Access Compliance Report

Public Rights-of-Way

(Curb Ramps)

Intersection ID: N/A	Main Street: ARDREY_KELL_DR	Cross Street: N/A	Location: SW
ADA ID: E8D05185B024	Ramp Type: Para	Initial Pass/Fail: Fail	Overall Compliance: No
		Severity Score: 12.5

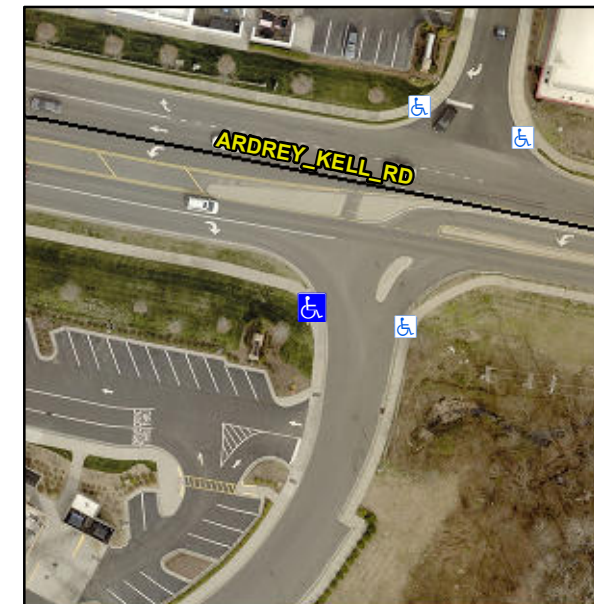
R304.3.2

Compliance	Description	Data	Compliance	Description	Data
N/A	Ramp Length LT (in)	72.0	N/A	Ramp Length RT (in)	62.0
Yes	Ramp Width LT (in)	74.0	Yes	Ramp Width RT (in)	74.5
Yes	Ramp Slope LT (%)	1.1	No	Ramp Slope RT (%)	10.1
Yes	Ramp XSlope LT (%)	1.4	Yes	Ramp XSlope RT (%)	0.8
N/A	Landing Length (in)	N/A	N/A	DWS Provided?	N/A
N/A	Landing Width (in)	N/A	N/A	DWS Contrast?	N/A
N/A	Landing Slope (%)	N/A	N/A	DWS Length (in)	N/A
N/A	Landing X Slope (%)	N/A	N/A	DWS Full Width?	N/A
N/A	Landing Curb? (Y/N)	N/A	N/A	DWS Offset (in)	N/A
N/A	Shared Landing?	N/A			
N/A	Gutter Ponding?	N/A	N/A	Gutter Slope (%)	N/A
N/A	Gutter Lip Ht (in)	N/A	N/A	Gutter X Slope (%)	N/A
N/A	Painted X Walk1?	No	N/A	Painted X Walk2?	N/A
	X Walk 1 Direction	To E		X Walk 2 Direction	N/A
N/A	X Walk 1 Width (in)	N/A	N/A	X Walk 2 Width (in)	N/A
	X Walk 1 Slope (%)	1.7		X Walk 2 Slope (%)	N/A
	X Walk 1 X Slope (%)	3.6		X Walk 2 X Slope (%)	N/A
N/A	Ramp inside XWalk1?	N/A	N/A	Ramp inside XWalk2?	N/A

Remove & Replace Entire Ramp.
